STAFF'S
REQUEST ANALYSIS
AND
RECOMMENDATION

04TS0128

Cobbs Point, LLC
Point Of Rocks Landing, LLC
and Southbend Landing, LLC
(Cobbs Point)

REQUEST: Tentative plat approval of Cobbs Point, Section 2, with an exception to having more than fifty (50) lots off a single access, as provided by Section 17-76(h)(5).

ATTACHMENT D

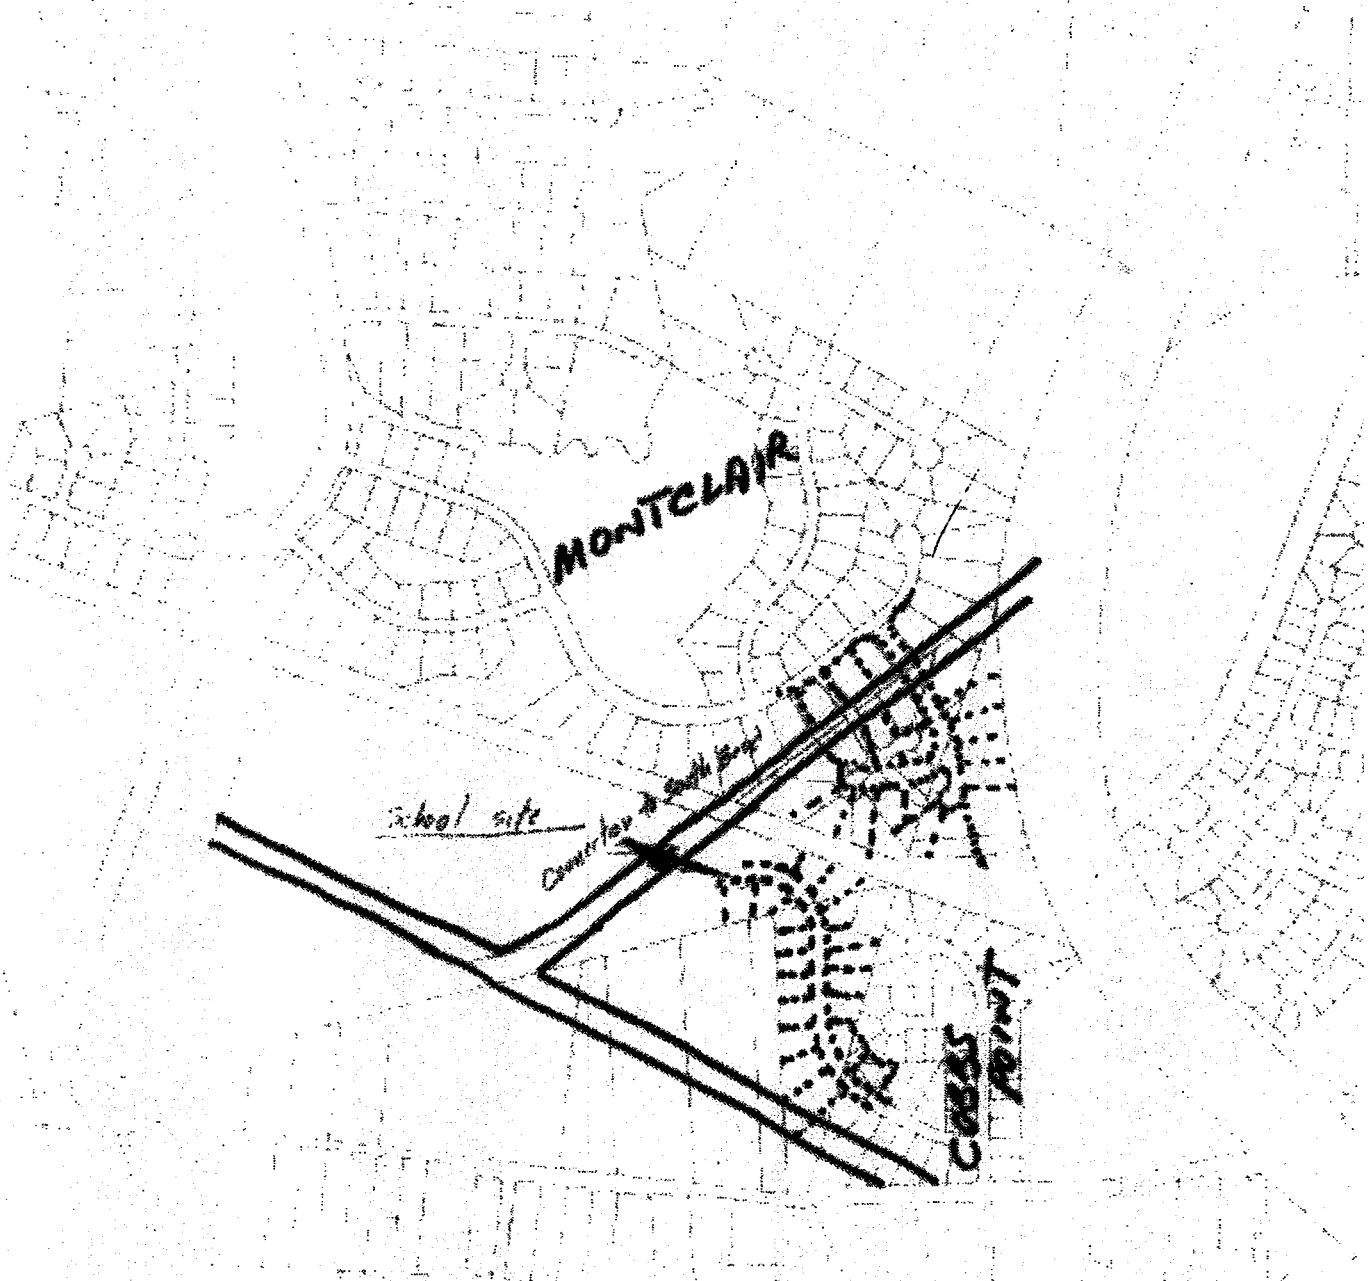
During the review of the zoning case, staff was presented with two (2) alternative plans that demonstrated an ability to comply with the Subdivision Ordinance access requirements. The first plan depicted a connection to Enon Church Road (See Attachment D) and the second showed a connection through property donated as a school site but which would connect to Sycamore Springs, another subdivision being proposed by the same subdivider that is currently under tentative review (See Attachment E). It remains a possibility to connect these two (2) subdivisions across property owned by the subdivider and not involve the County property.

**ACCESS
NEEDED**

- 26 LOTS
- ASSUME R-12 ZONING
- SEWER EXTENSION THRU SOUTH BEND
- WATERLINE FROM ENON CHURCH ROAD.
